FIELD INSPECTION

Project Name:	Mountain Valley Pipeline	Inspector:	Matthew Grant
Inspection Date:	Tuesday, March 5, 2019	Project Contact:	Brian Clauto
Spread: Pittsylvania County MP 299-300 St#15838-15865 MP285 St#15084- 15092 MP570 St#15055+88	Spread I	Weather (Wet/Dry/Rain):	Wet

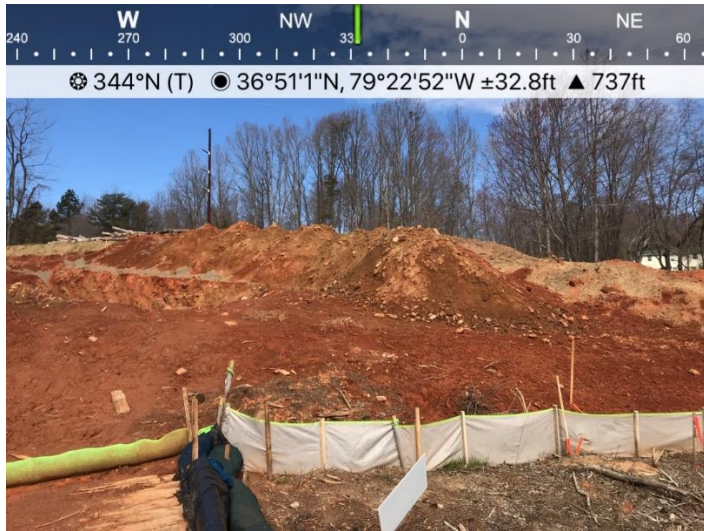
- Streams / wetlands inspected included S-G2, W-G2, S-G9, S-D1-EPH.
- St#15850+56 stockpile lacks stabilization
- St#15865+00 level spreader lacks end cap
- St#15084+00 CWD has been breeched
- St#15086+00 CWD inlet has eroded
- St#15092+95 CFS waddle is torn
- St#15093+75 stockpile lacks stabilization
- St#15055+88 at S-D1-EPH stream bank has eroded from and sediment has entered the stream

Recommended Corrective Action: Maintain all controls per the approved plan and specs, remove sediment and stabilize per DEQ approval.

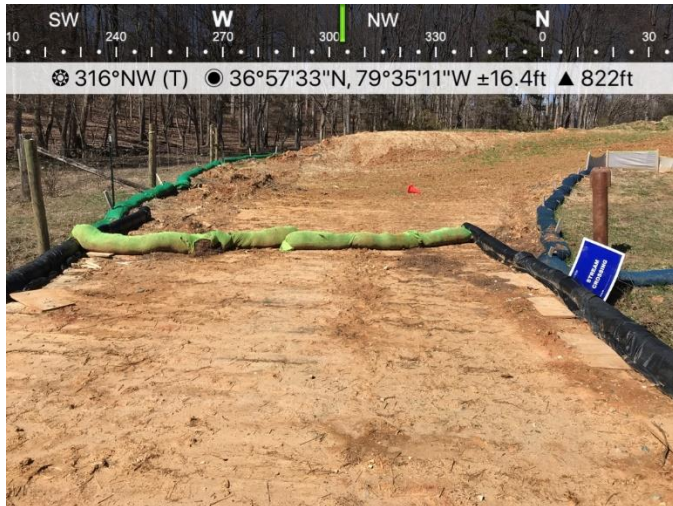
- Fig. 1 St#15850+56 stockpile lacks stabilization

- Fig. 2 St#15865+00 level spreader lacks end cap

- Fig. 3 St#15084+00 CWD has been breached

- Fig. 4 St#15086+00 CWD inlet has eroded
